Varimixer

New shape

Standardization of knee and foot design across AR30, AR40 and AR60 variants

Affected parts:

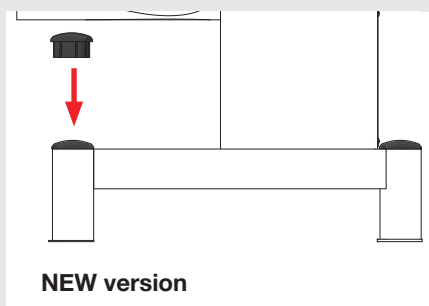
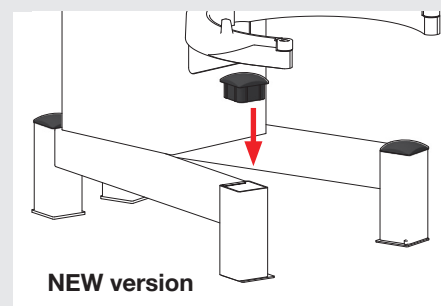
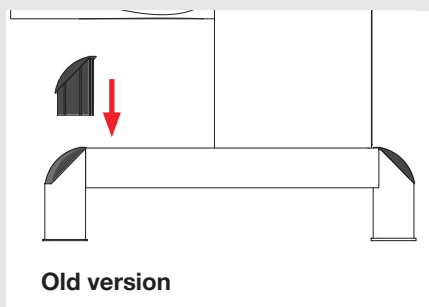
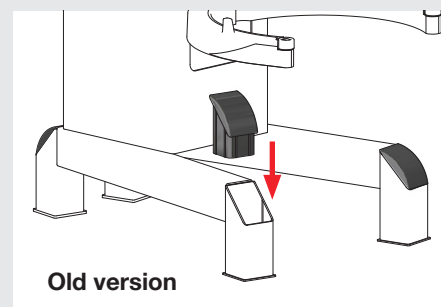
Knees, feet and spacer blocks used on AR30, AR40 and AR60 stands. The design is standardized across all stand variants. Related spare part kits and service kits have been established with new item numbers to support both legacy and new designs.

To improve the quality of the plastic knee component through updated mould tooling and a revised design. The new design also provides better coverage of the foot, reducing the risk of water ingress. In addition, the knee and foot design has been standardized across AR30, AR40 and AR60 stands, reducing part variation and simplifying inventory management.

Previously, AR30/40 and AR60 used different component designs. The new common design replaces the previous variants, reducing part complexity and simplifying production, inventory management and service support. Production kits and related BOM structures have been updated accordingly.
